## Riley Purgatory Bluff Creek Watershed District Permit Application Review

**Permit No:** 2023-038

**Applicant:** Mister Carwash, Prabhs Matharoo

**Project:** The applicant proposes the construction of a car wash facility and associated site improvements including grading, curb and gutter, pavement surfacing, and utility services in Eden Prairie, MN. The project includes an underground stormwater management facility with on-site irrigation, a Jellyfish filter, and Contech stormfilter to provide volume control, water quality, and rate control.

**EROSION CONTROL PLAN**

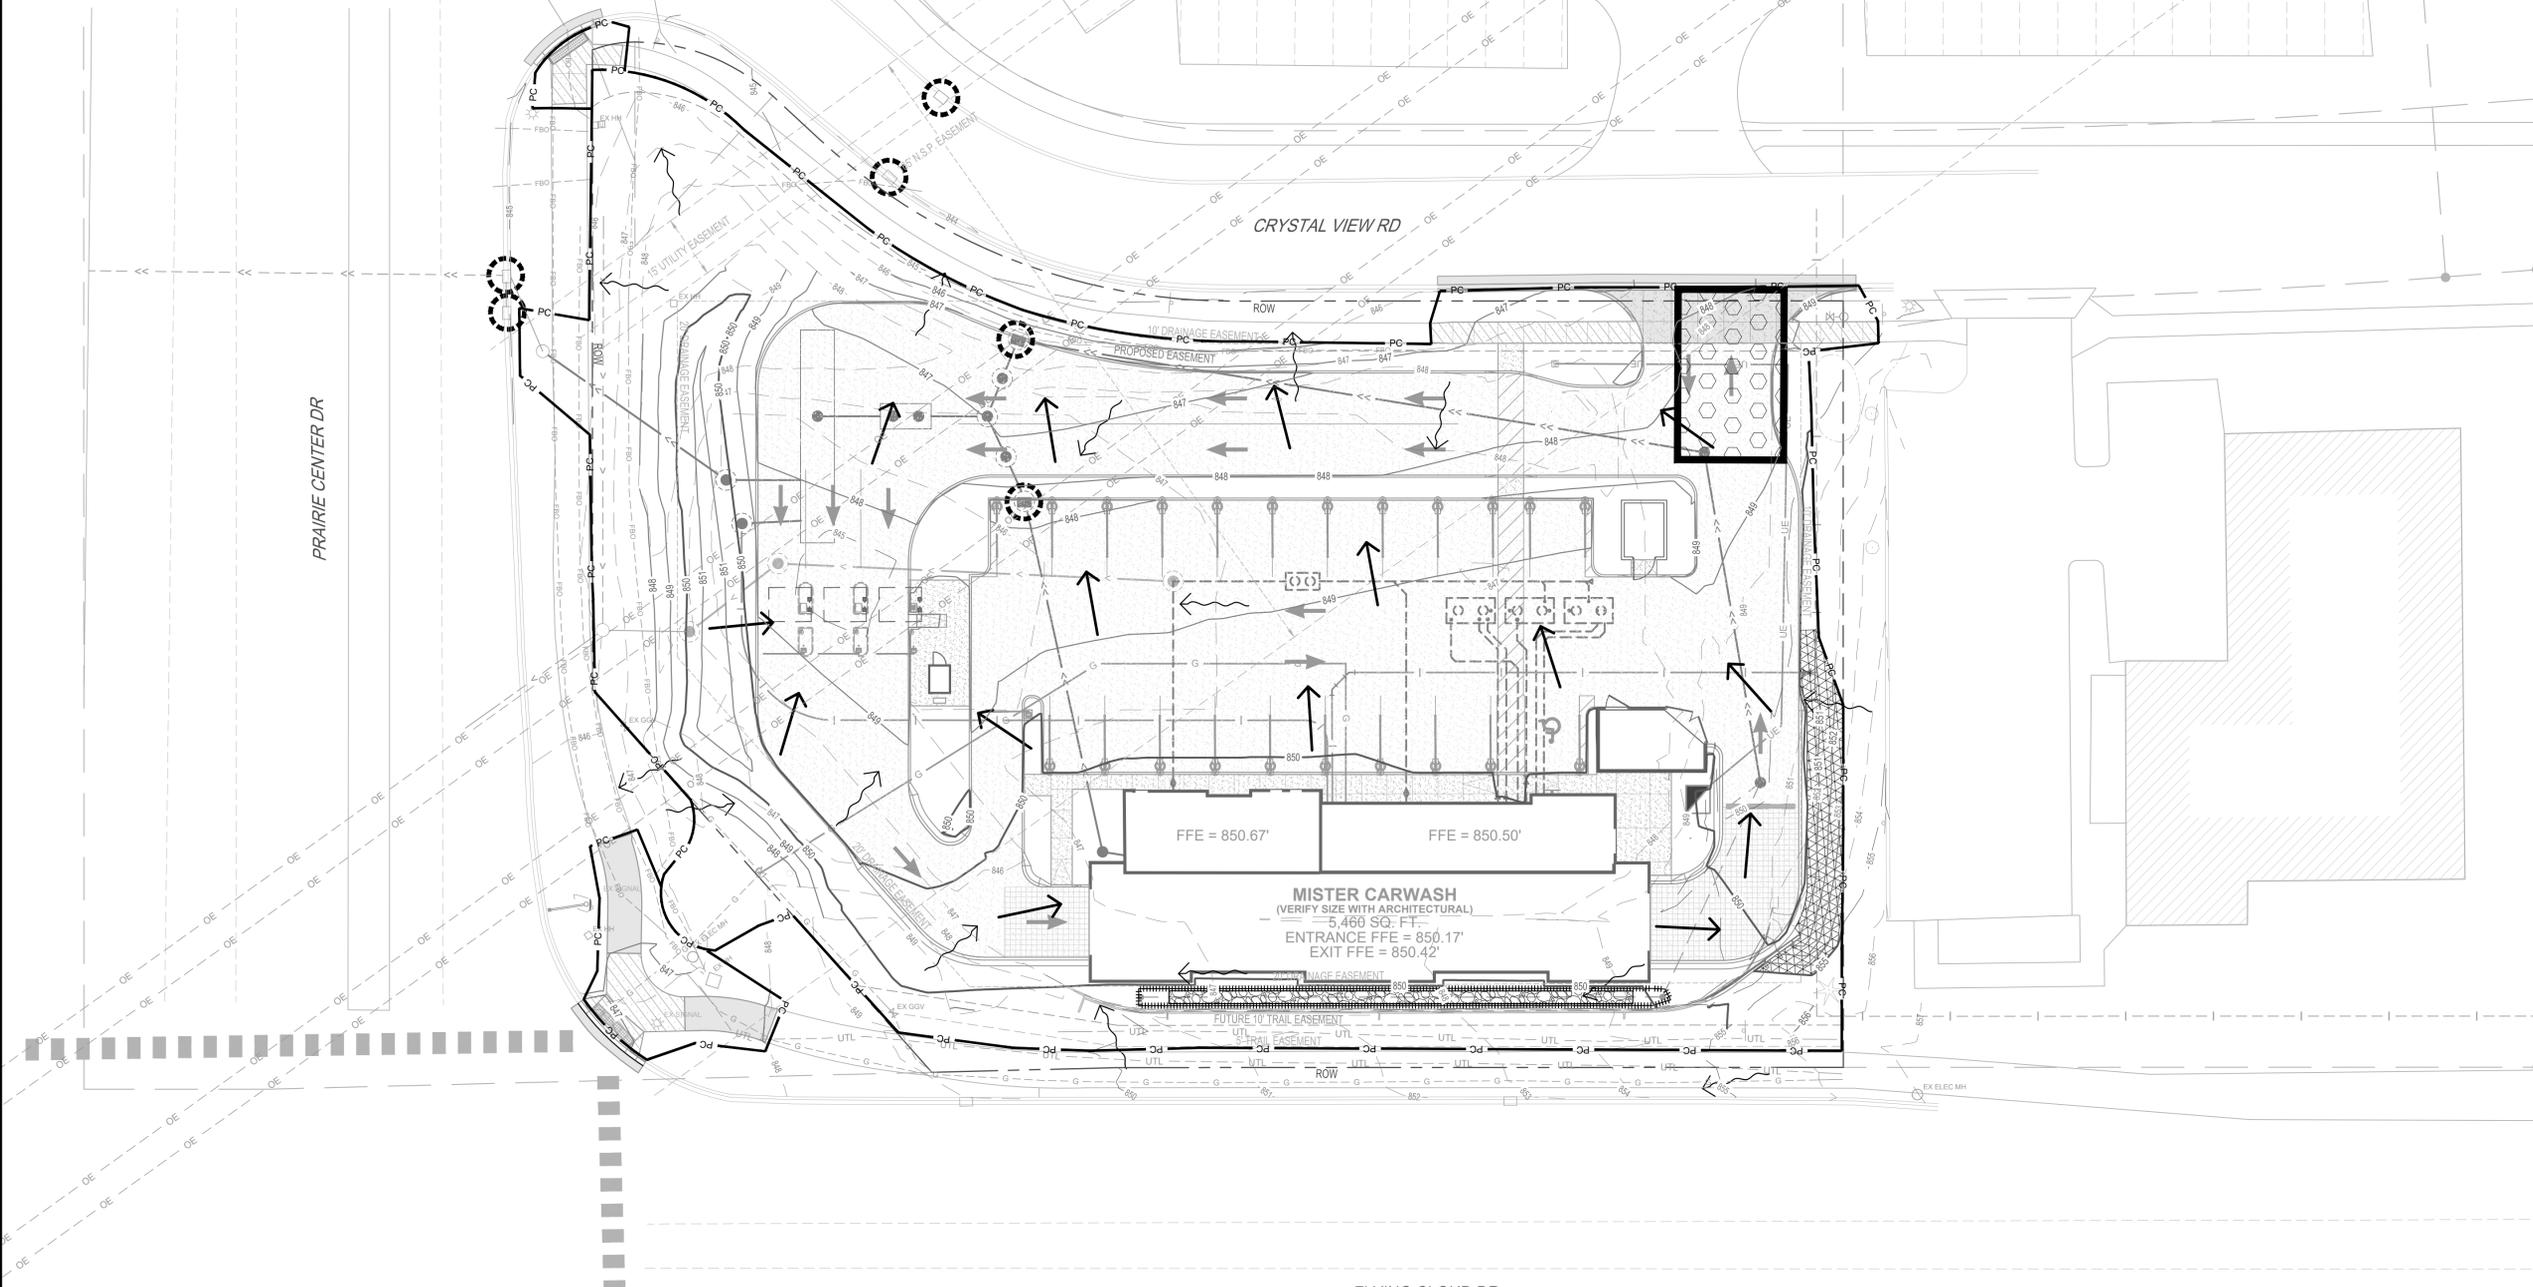
The erosion control plan prepared by ISG Inc. includes installation of perimeter control (silt fence or sediment control logs), a stabilized rock construction entrance, inlet protection, weekly inspection, staging areas, placement of a minimum of 6 inches of topsoil (at 5% organic matter), and decompaction of areas compacted during construction. To conform to RPBCWD Rule C requirements, the following revisions are needed:

- C1. The Applicant must provide an erosion control plan that clearly identifies all locations with temporary erosion prevention measures including slope stabilization.
